MINUTE NO. 181

REQUEST OF MAVERICK COUNTY WATER CONTROL AND IMPROVEMENT DISTRICT NO. ONE TO CONSTRUCT, OPERATE AND MAINTAIN A DIVERSION DAM ACROSS THE RIO GRANDE ABOUT 42 MILES (67 KILOMETERS) UPSTREAM FROM EAGLE PASS, TEXAS AND PIEDRAS NEGRAS, COAHUILA.

JOINT REPORT OF THE CONSULTING ENGINEERS
REGARDING THE PROPOSED CONSTRUCTION OF A DIVERSION DAM ACROSS THE RIO GRANDE
ABOVE EAGLE PASS, TEXAS

Plan of Proposed Dam
Scale 1" = 40'

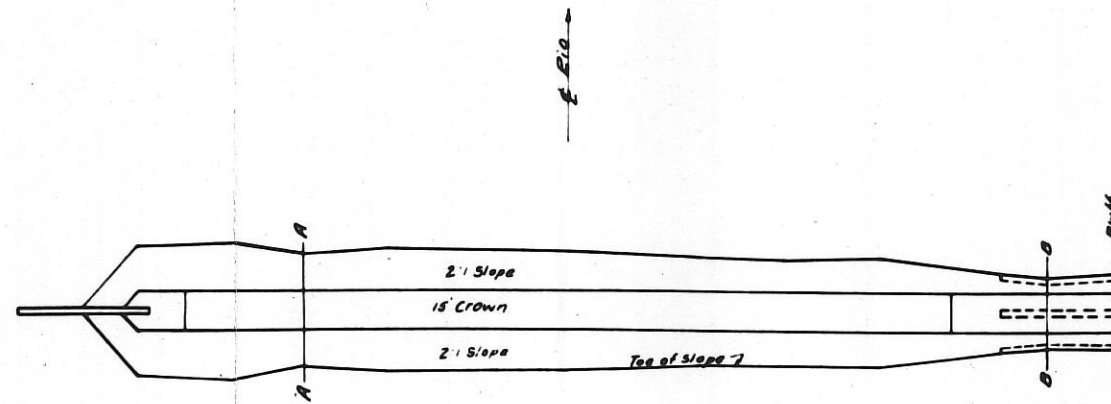
A copy of the structure plans submitted by the District is attached and these show that the proposed dam will have a 15-foot crown

with 3 to 1 side slopes, both upstream and downstream. Its over-all length will be 440 feet, and the length of the low water overflow crest will be 300 feet at an elevation of 819 feet, which is approximately 4 feet above the present low water surface of the river. Wing extensions of the overflow crest on both the United States and Mexican sides are 70 feet in length, and the top rises from the crest elevation of 819 feet to an elevation of 822 feet at the outer end of the wings. The dam proper will be constructed as a loose rock fill, with the voids in the rock filled with sand and gravel, and with the crown and upstream and downstream slopes grouted with concrete to a depth of not less than 2 feet.

a masonry cut-off wall set on solid rock and extending well into the low flow river bank is proposed on the United States end of the structure. On the Mexican bank, masonry cut-off walls tied into the bluff will be built on both the upstream and downstream toes of the structure and will be carried 6 inches into bed rock.

The protection of the Mexican end of the dam could consist of grouted slope paving about eight feet high, from the top of the dam, and extending about twenty-five feet upstream and downstream from the center-line of the dam. The protective work across the low ground on the United States side could consist of a low embankment with an initial elevation of 825 at the end of the cut-off wall, a gradual rise to contour elevation 830, and an embankment crown elevation of 830 until the high bank is reached. This embankment could serve also as an access road from the high ground to the dam and could be built of durable material and surfaced with gravel. The low area to either side of this embankment should also be planted to grass as a further measure of stabilization.

It is recommended that the request of the District be granted, provided that the changes in the plan, substantially as suggested, be incorporated in the work; that the District install and operate at the head of the canal and at the points where water is returned to the river, facilities, satisfactory to the Commission, to continuously measure the amount of water diverted from and returned to the river; and, that the Commission supervise the construction, operation and maintenance of the work.
